Access Compliance Report Public Rights-of-Way (Curb Ramps)

Main Street: PACIFIC_AVE Cross Street: GILBERT_ST Location: SE

ADA ID: RPT1210915175157 Ramp Type: Type 4 - Parallel Initial Pass/Fail: Pass Overall Compliance: No Severity Score: 0

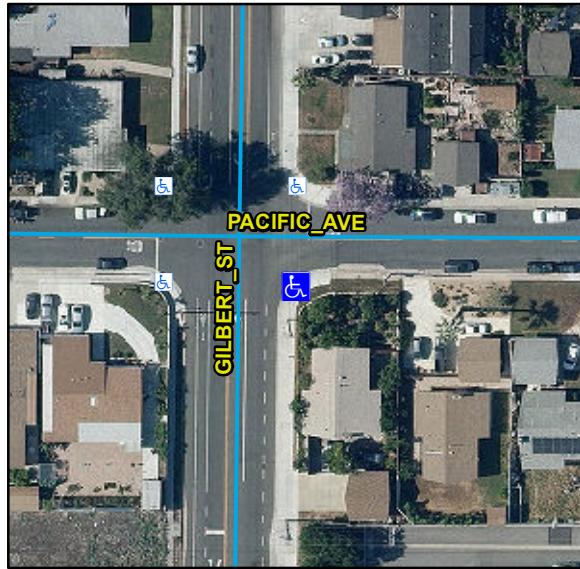
Remove & Replace Curb Slope.

R304.2.2, STD 1115
